18 THERMAL

650cc

PrintArea

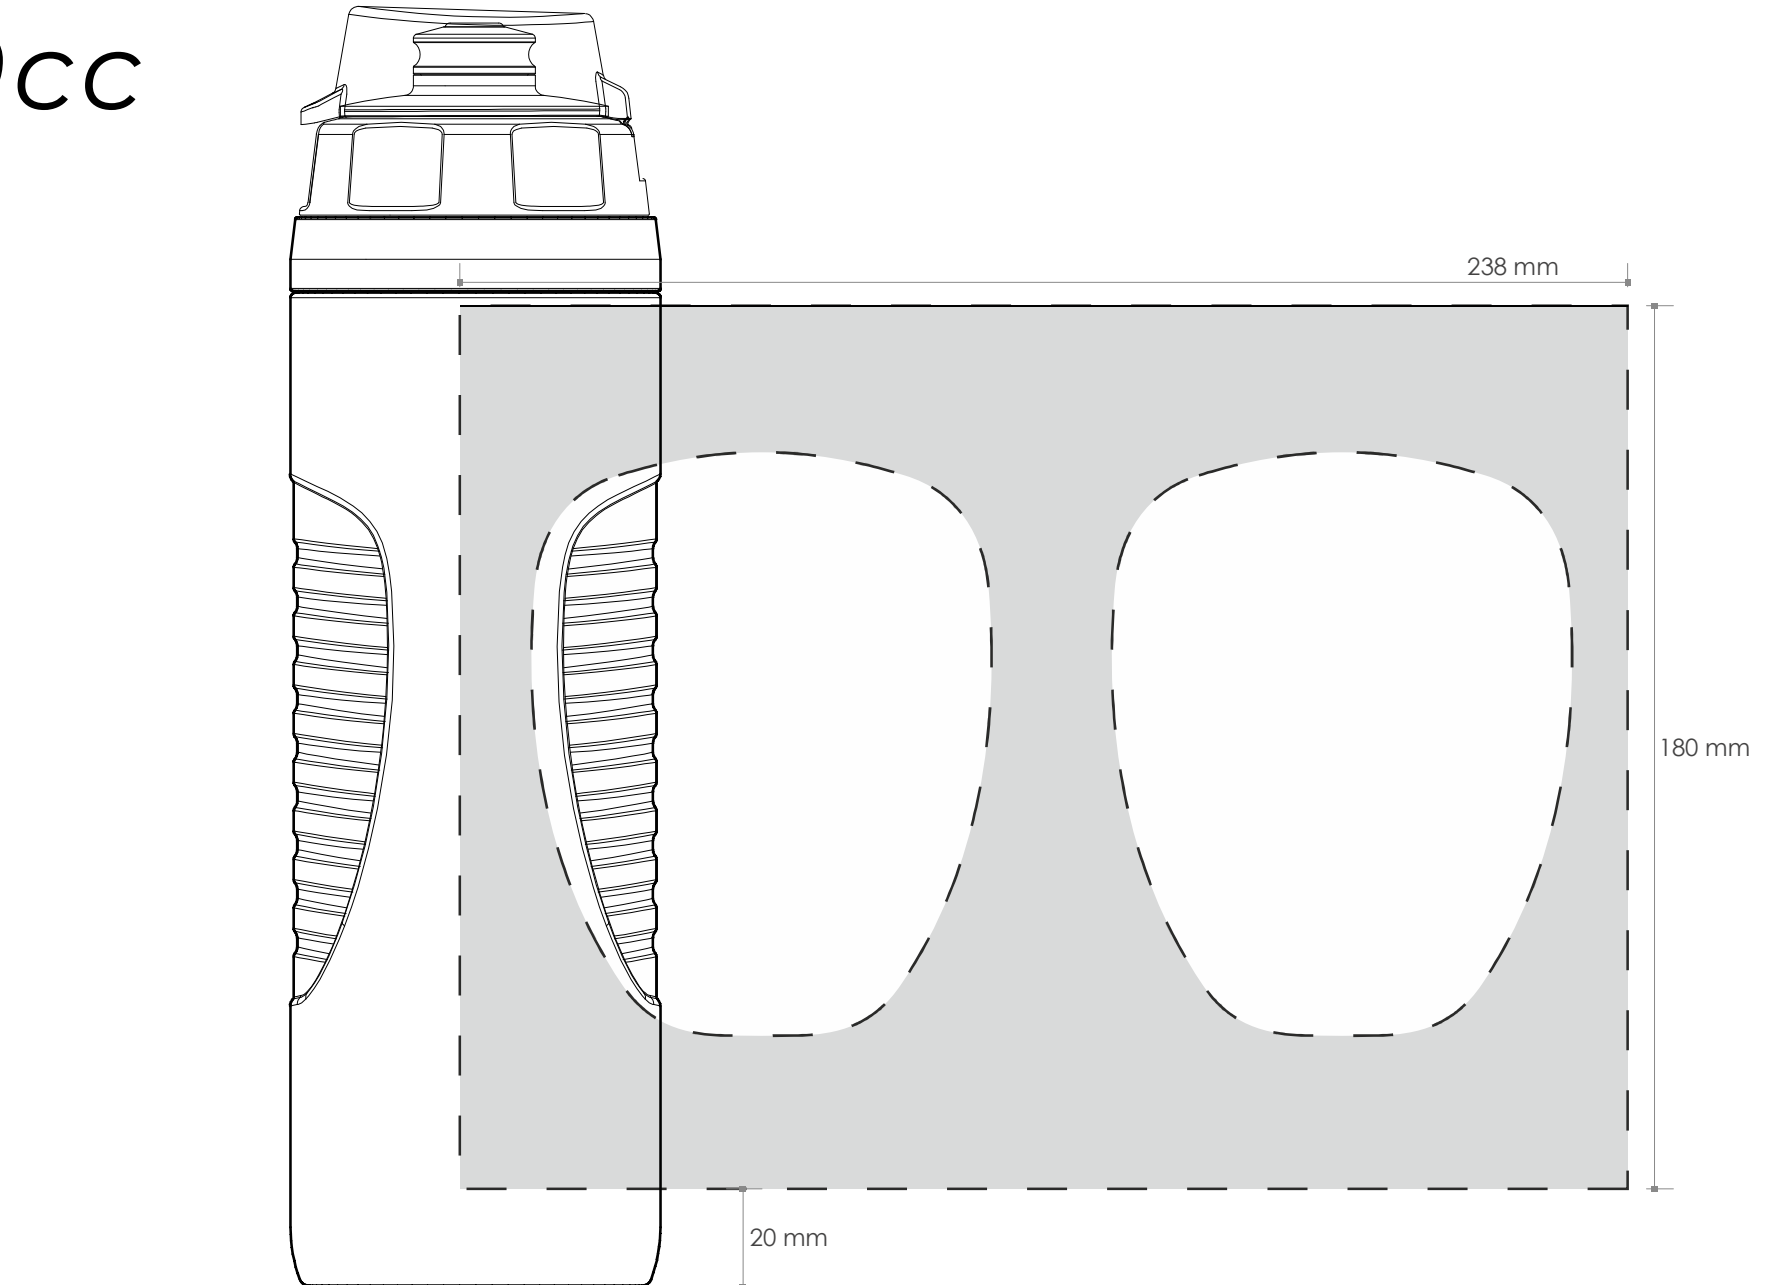
The impression can not close on the circumference of the bottle:
it's necessary to consider a non-printable area (approx. 0,8 cm width)
